Zoning Staff Report

Case Number: ZC-22-200

Zoning Map Amendment & Site Plan

Owner / Applicant: Albaro Becerra / Raymond & Alex Ayala, Sluggers Training Facility & Ballfields

OVERALL SITE PLAN

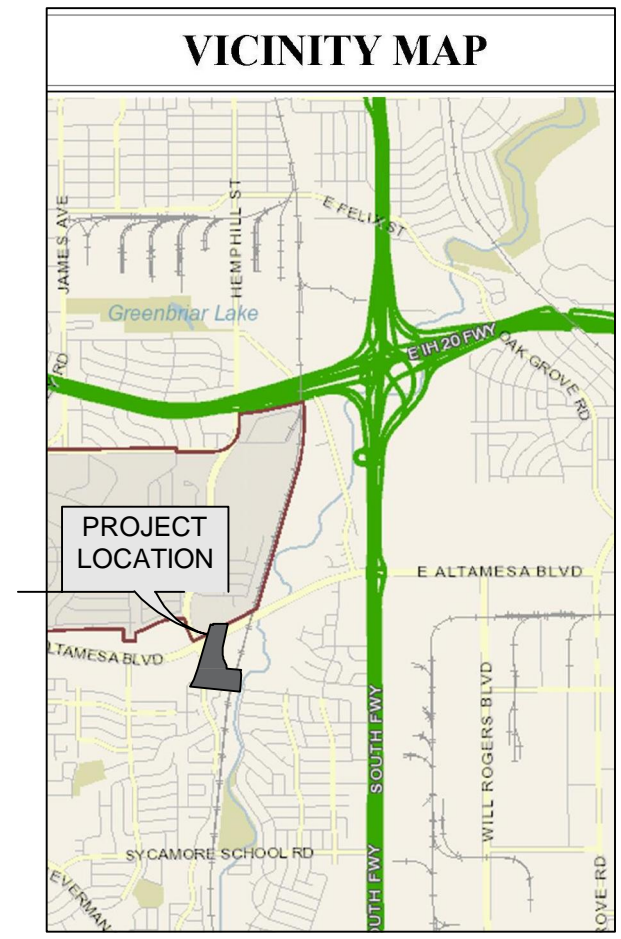
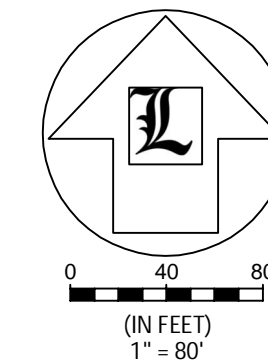
Zoning related comments – greyed out since they have all been addressed:

- Remove Floor Area Ratio line
 - Email pdf of updated Site Plan with comments addressed (do not include application or signature pages). Need no later than the end of this week (Dec. 2)

- Revise calculation using "Open Space" definition in Chapter 9, Zoning Ordinance. Discount all building footprints, PLUS all parking areas and access drives. Outdoor recreation areas can count as open space.

- Should read "20 foot minimum where "E" abuts "A-5" zoning"
 - Add to buffer yard / screening row: [under "E" standards: "5 foot landscaped buffer yard and 6 foot high solid screening fence required along northern, eastern, and southern property lines where "E" abuts "A-5" zoning". For the "Proposed PD-E" column, add Waiver Request: To not provide 5 foot landscaped buffer yard and 6 foot high solid screening fence along northern, eastern, and southern property lines (unless you intend to provide this - otherwise you need the waiver request)

- "E" height is 45' or 3 stories, not 50', revise
 - 173 spaces shown on plan - revise count
 - Should be 115 required (88+27) not 114
 - Add row for Landscaping requirements / waiver request. See section 6.301.h.1 for landscaping requirements.

- Add case reference ZC-22-200
 - Provide PD waiver exhibit
-
